NEW CONTACTS FOR CONNECTOR N | 1/1 | 2

OUR REF.NO 040

NEW RELEASE PLATE FOR AUTO BELLOWS 1/2

OUR REF.NO. 021

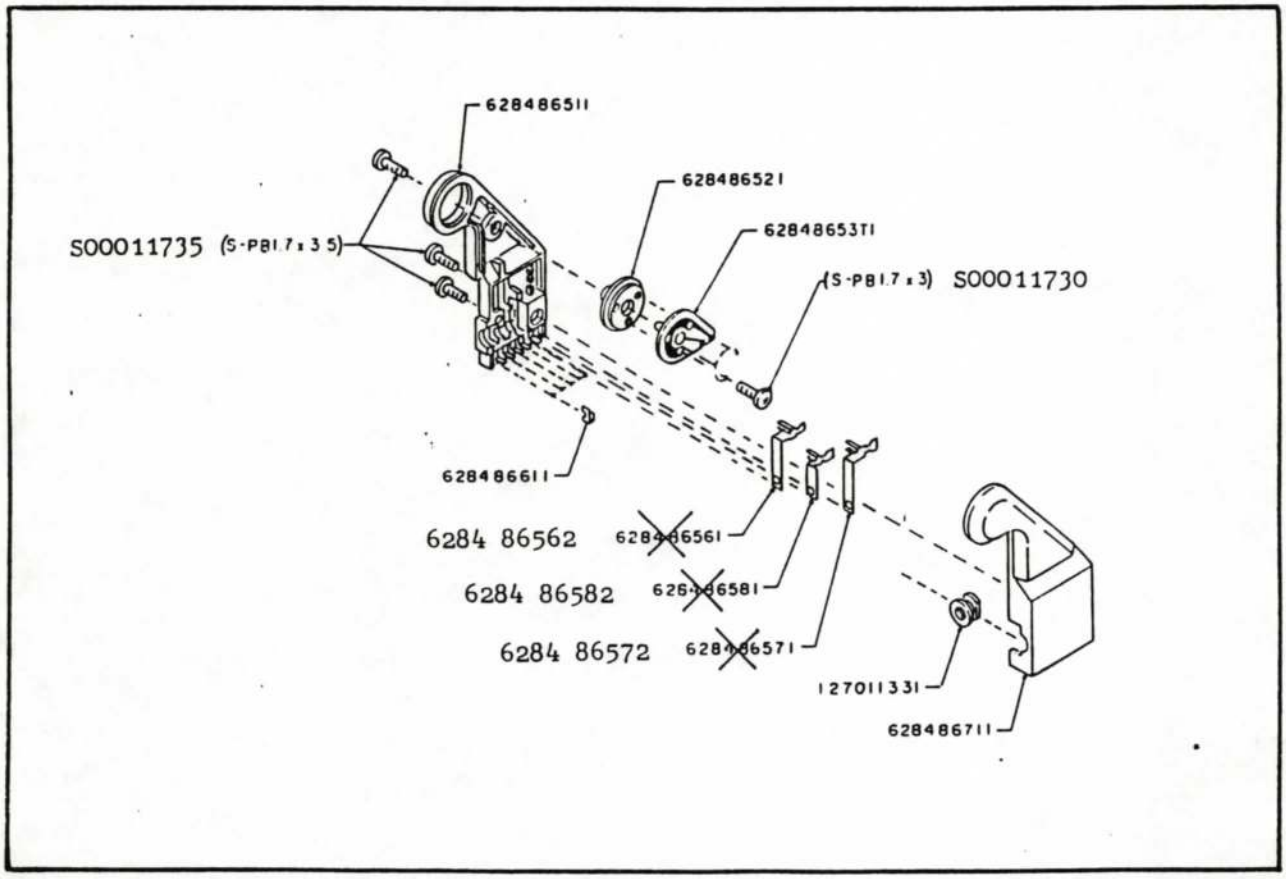
1. CAUSE : Contact B,C, and D : Weakened.

2. MODIFICATION : Material of contact B,C, and D : Changed.

3. MODIFICATION DATE : Since 1987 March production.

New P/No. 6284 86562 Contact D
6284 86582 Contact B
6284 86572 Contact C

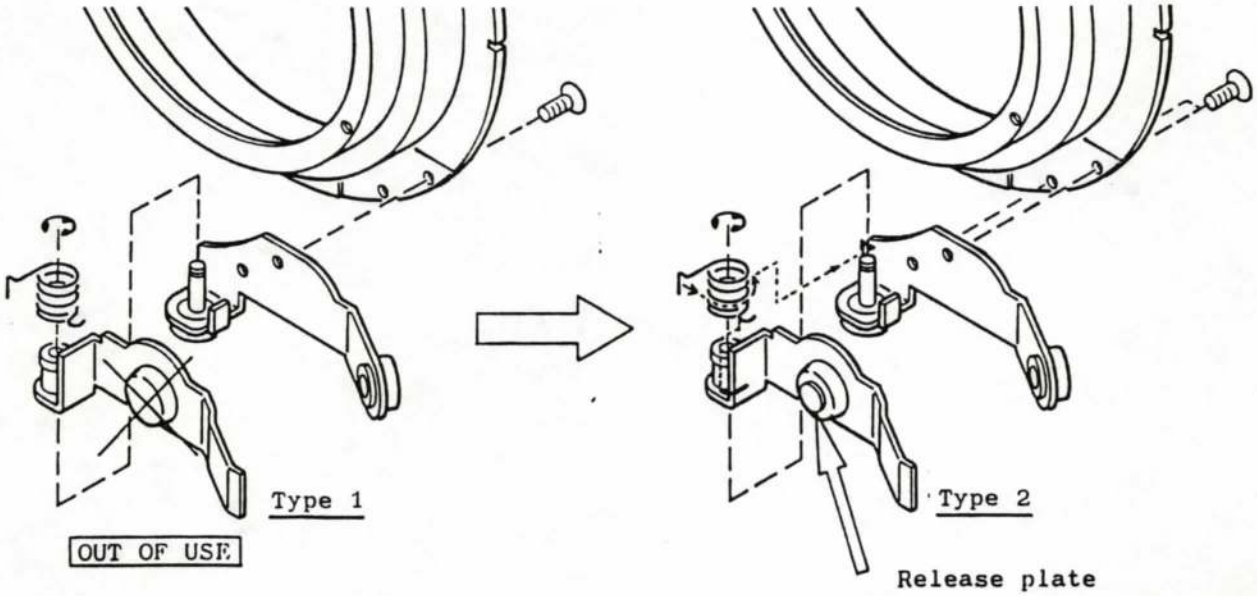
1. CAUSE : Release plate(type 1) does not push the release button of body.

2. MODIFICATION : Shape of release plate.

3. MODIFICATION DATE : From October, 1986.

4. REPAIR STEP : Replacement of release plate (type 2)
